GRADY ADDITION

SITE PLAN AND GRADING PLAN GRADY ADDITION		SHEET NO. 3 5
CITY OF ROCKWALL, ROCKWALL COUNTY, TEXAS		JOB NO. 85107

PLAT REVIEW

Agenda Item: P&Z 90-13-FP - Discuss and Consider Approval of a Site Plan and Final Plat for the Grady Addition

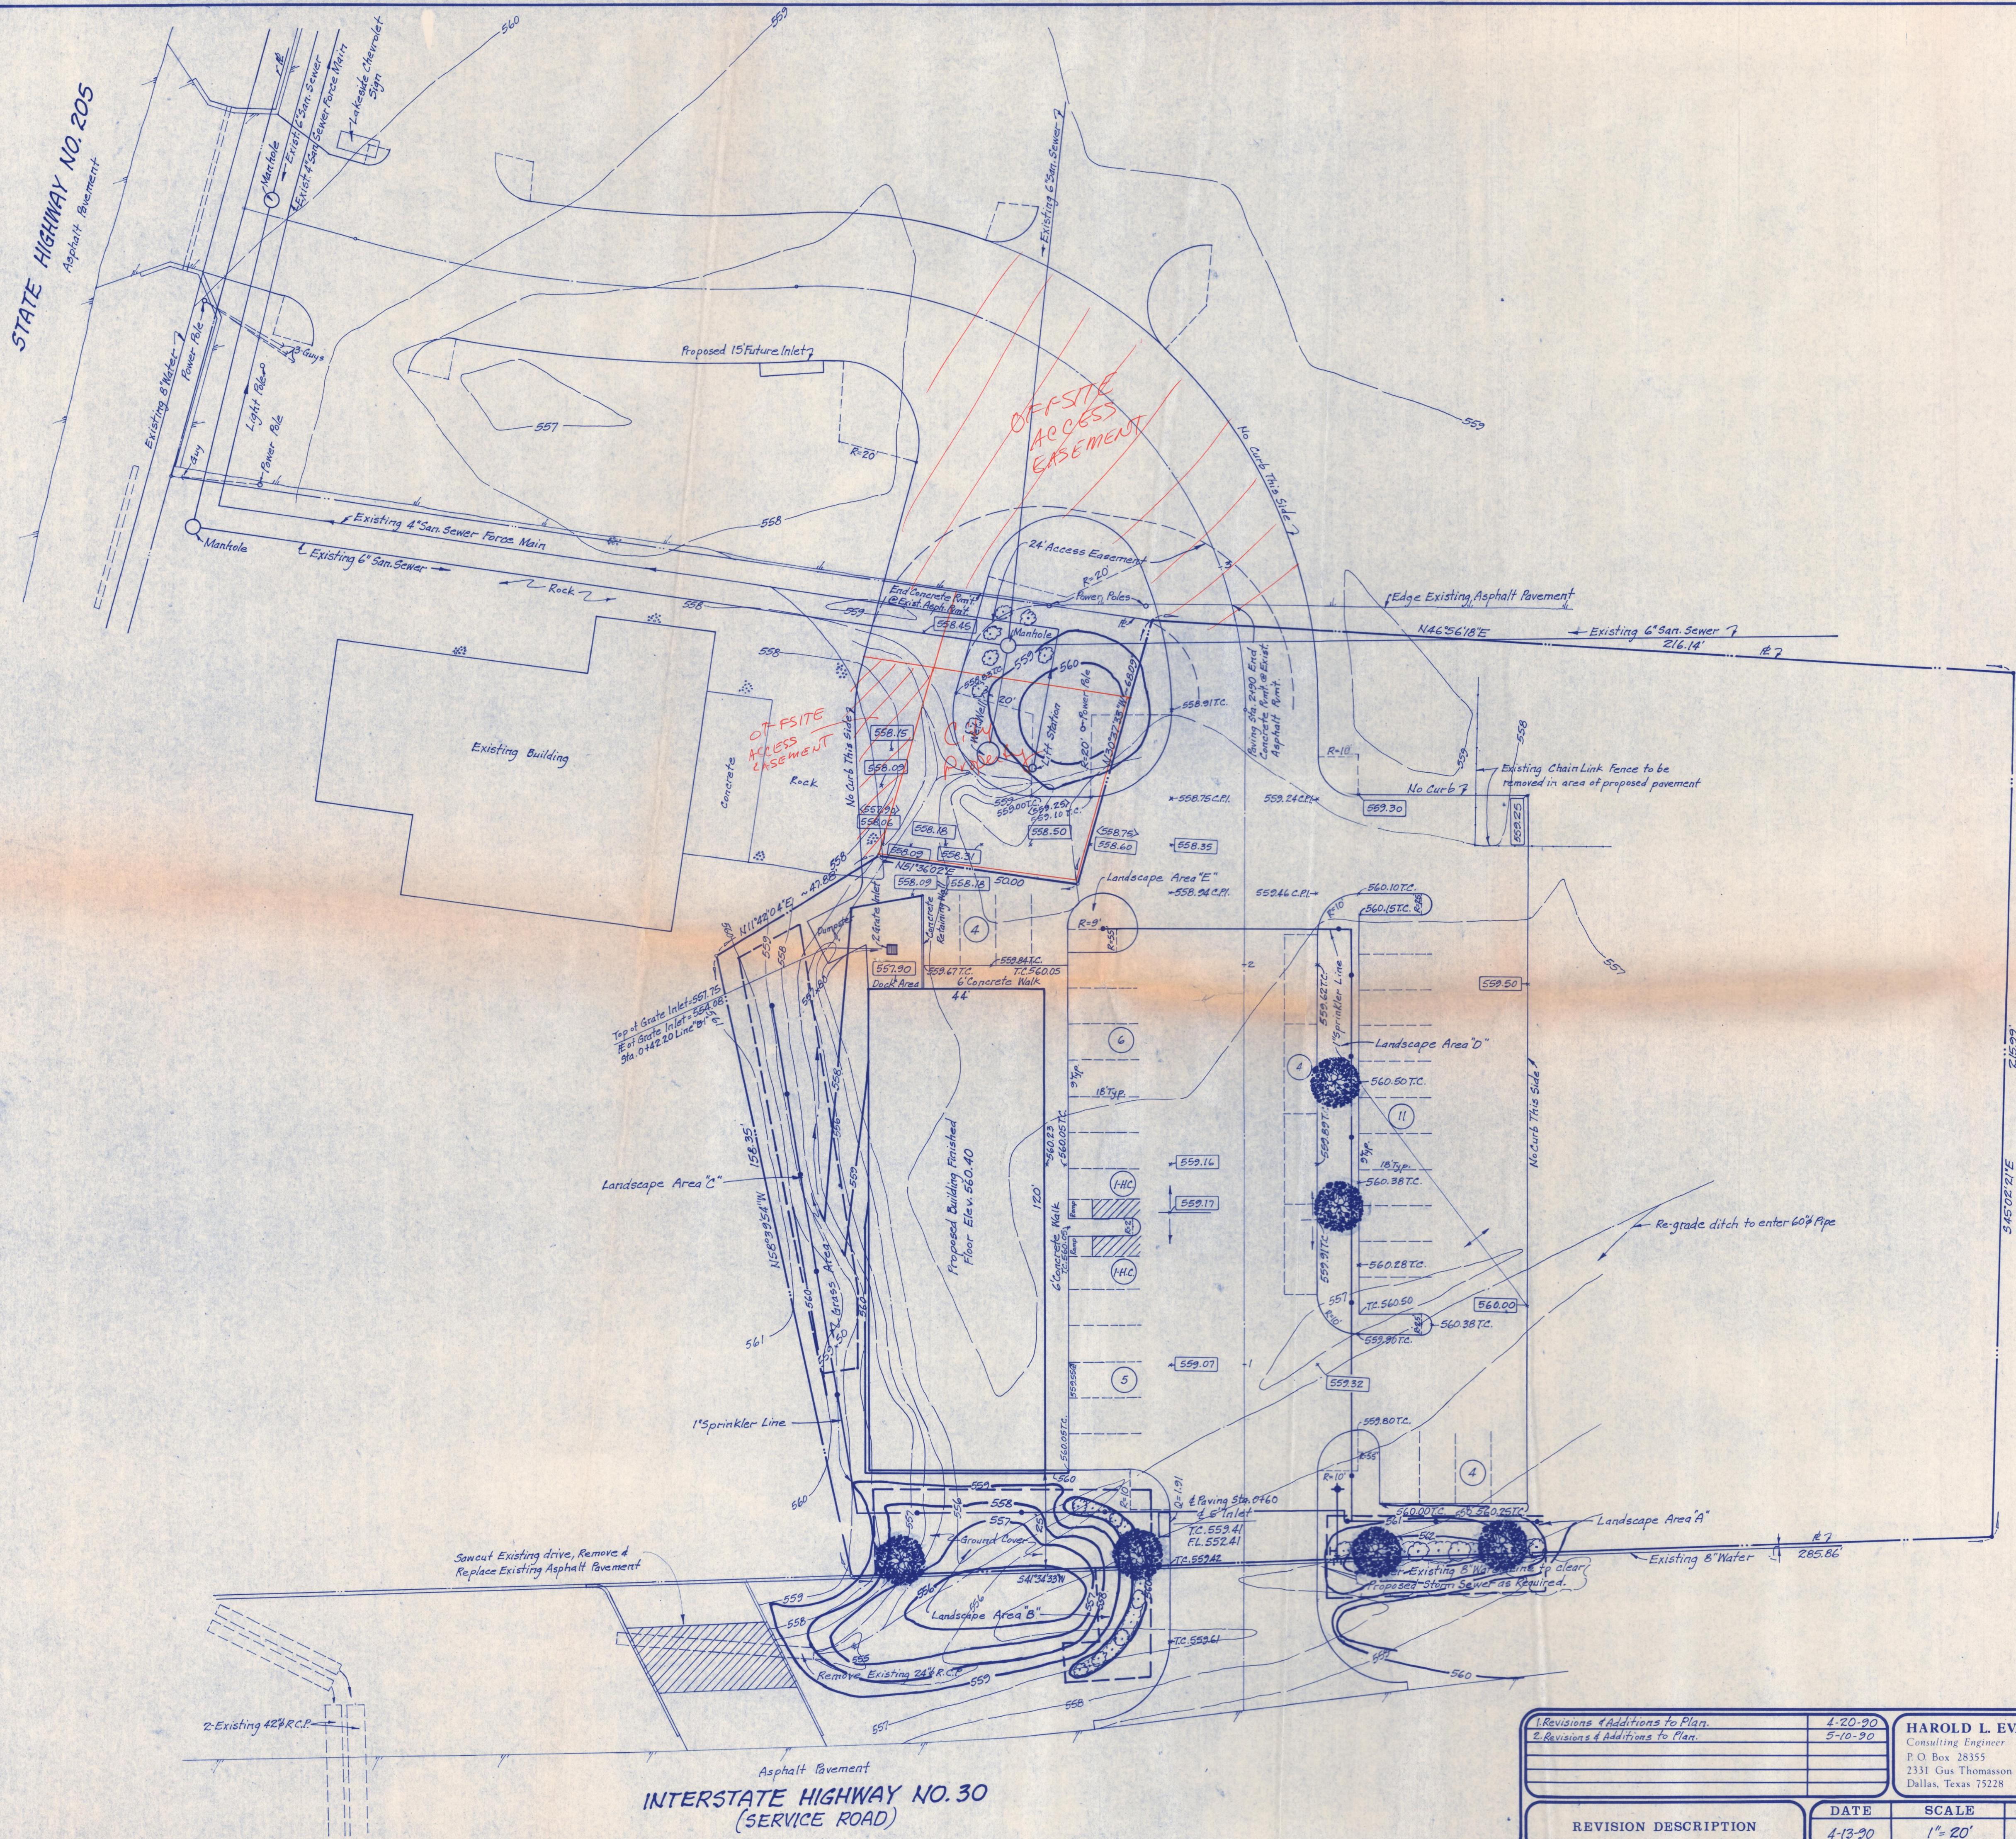
| n. | Are correct number of parking spaces provided? | <i>need to add spaces (opening on use of side)</i> | <input checked="" type="checkbox"/> | <input type="checkbox"/> |
| o. | Are driving lanes adequate in width? | <i>too wide</i> | <input checked="" type="checkbox"/> | <input type="checkbox"/> |
| r. | Is a fire lane provided? | <i>needs to be identified</i> | <input type="checkbox"/> | <input checked="" type="checkbox"/> |
| u. | Are drive entrances properly dimensioned? | <i>needs to be reduced</i> | <input checked="" type="checkbox"/> | <input type="checkbox"/> |

- ✓ 1. How will paving tie into existing on car lot and how will access work when lot is closed?
- ✓ 2. Reduce the drive to 24'
- ✓ 3. What is square footage of bldg
- ✓ 4. Need to landscape island and plant 2 large trees in landscaping
- ✓ 5. What about trash
- ✓ 6. are you proposing a berm in front?
what slope what height -
needs to be identified

✓ 2. Reduce Drive to 24'

9. Only need a 24' drive entrance not 37'

DRAINAGE IMPROVEMENTS AND GRADING PLAN
GRADY ADDITION

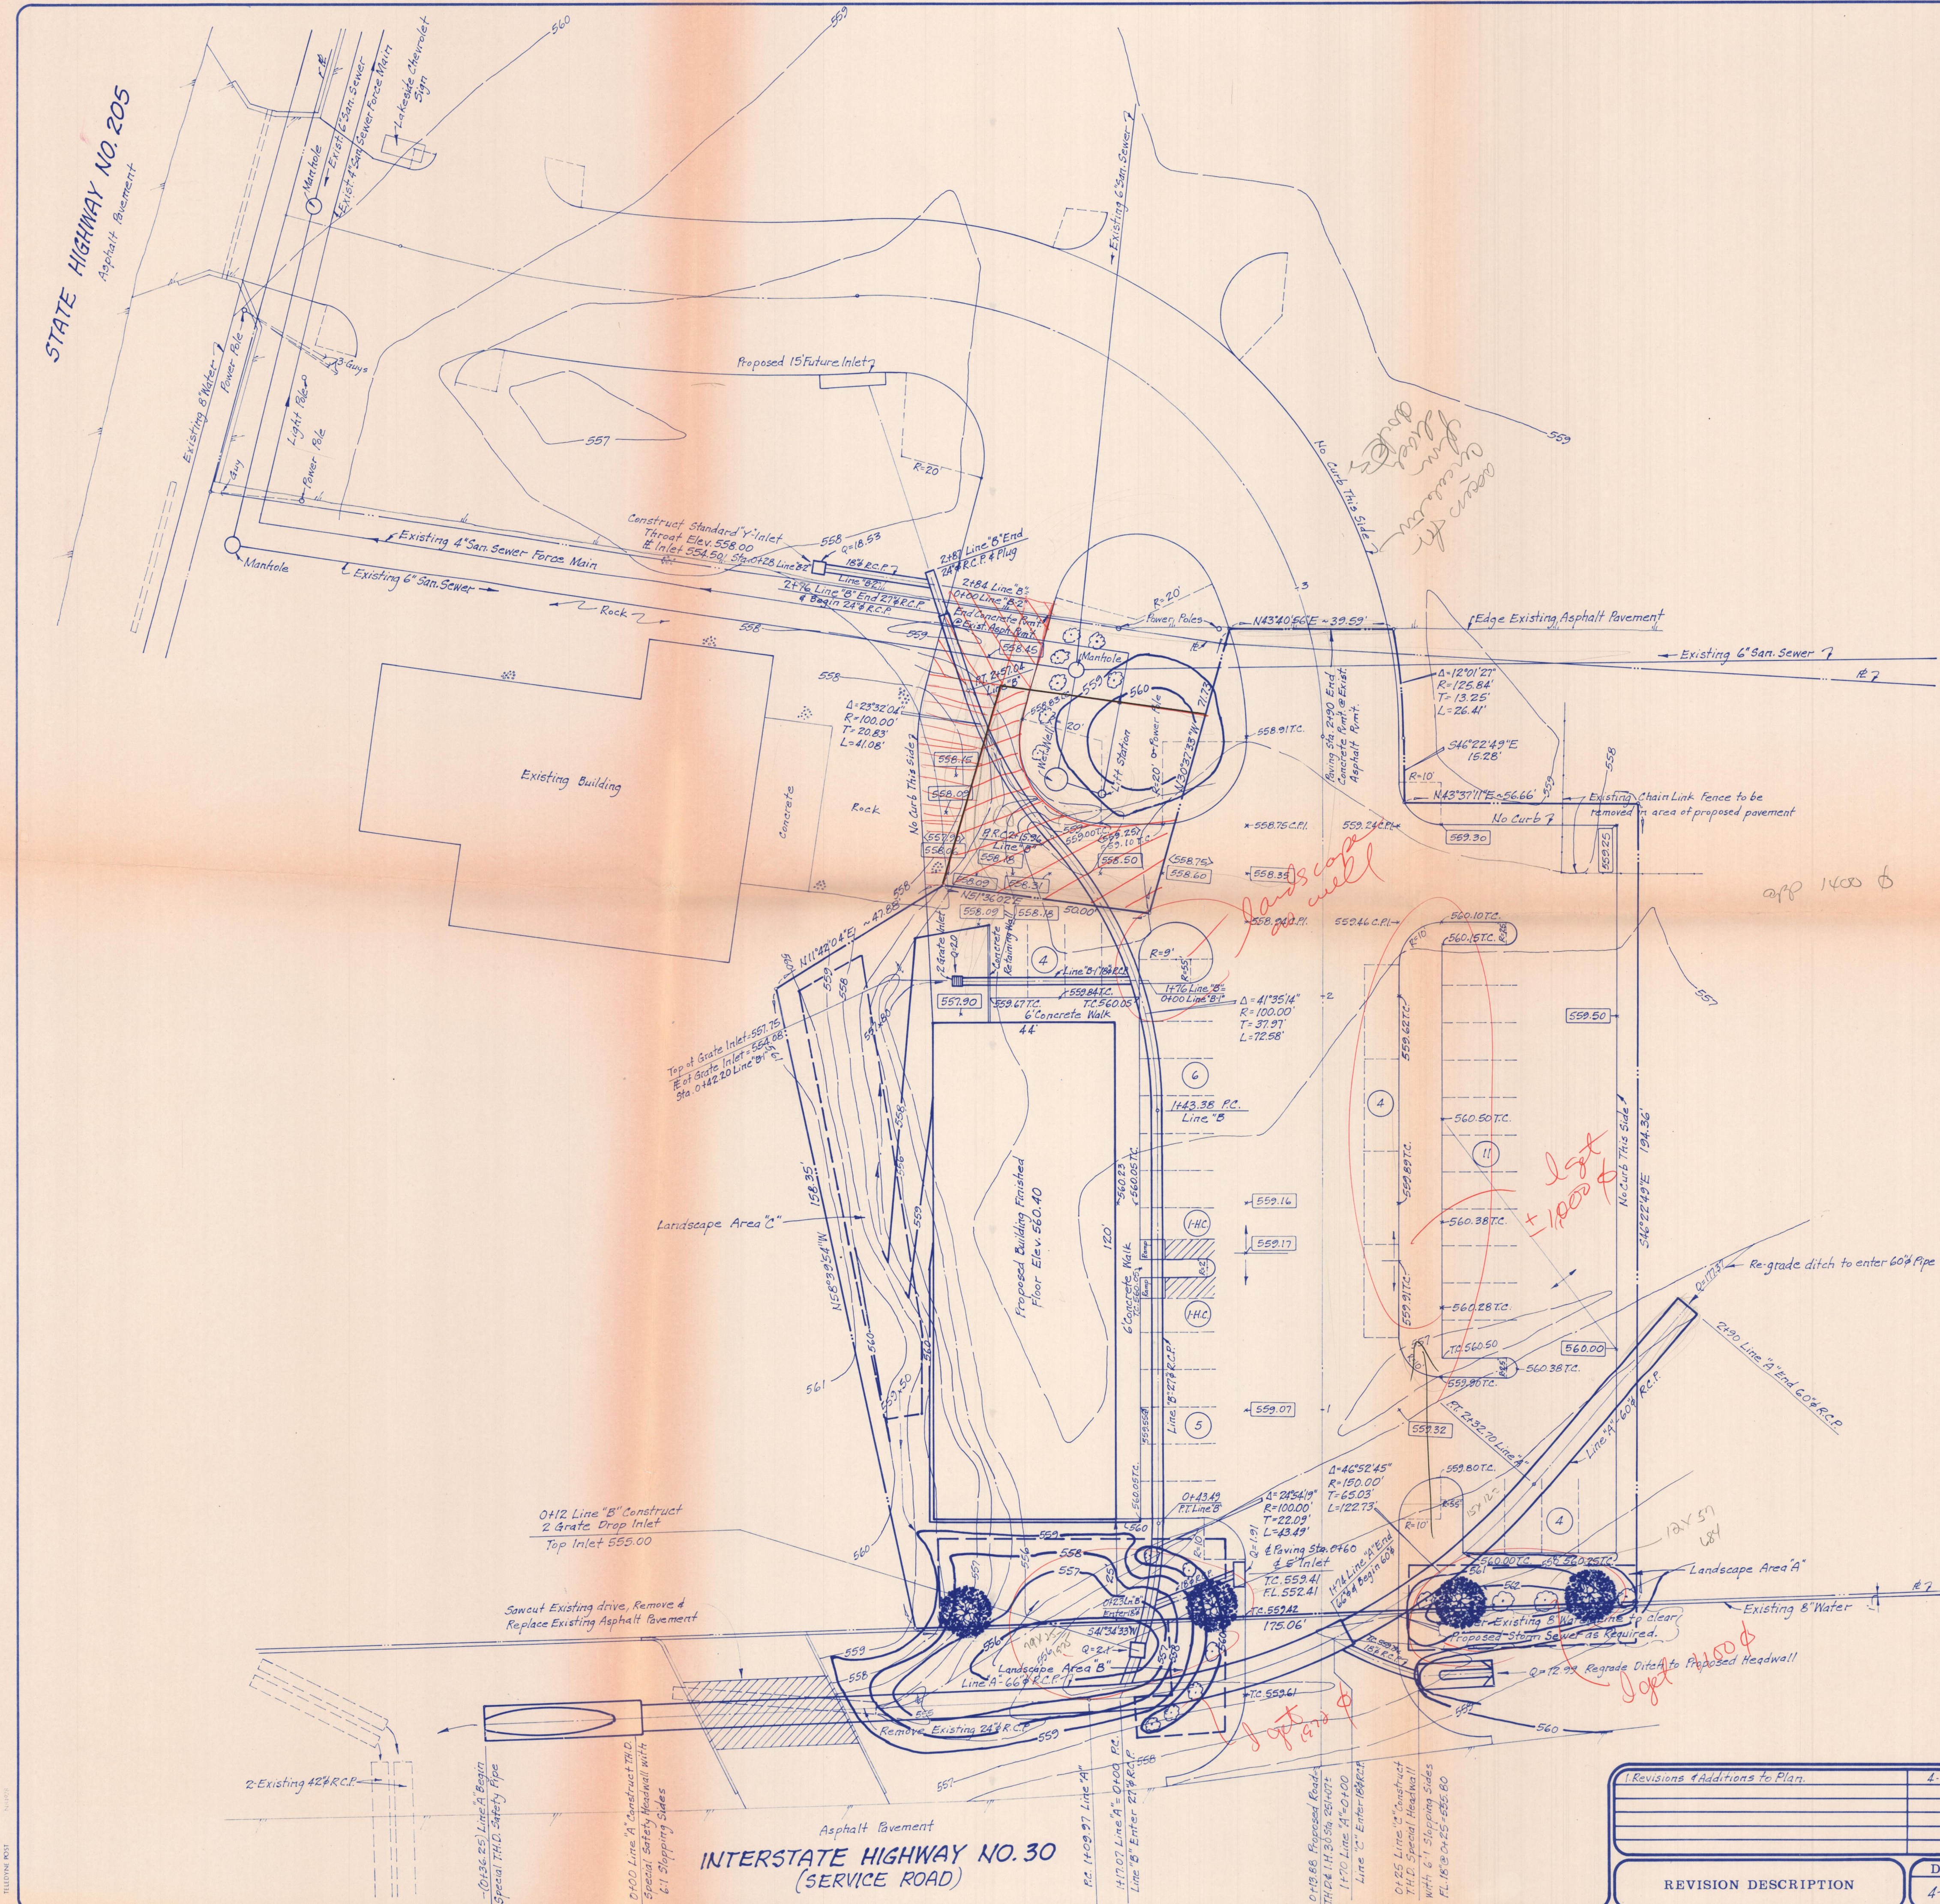
1. Is the street going to be privately maintained or dedicated?
2. All plans are to be sealed, signed, and dated before final acceptance.
3. Submit a copy of the proposed utility easement description for review.
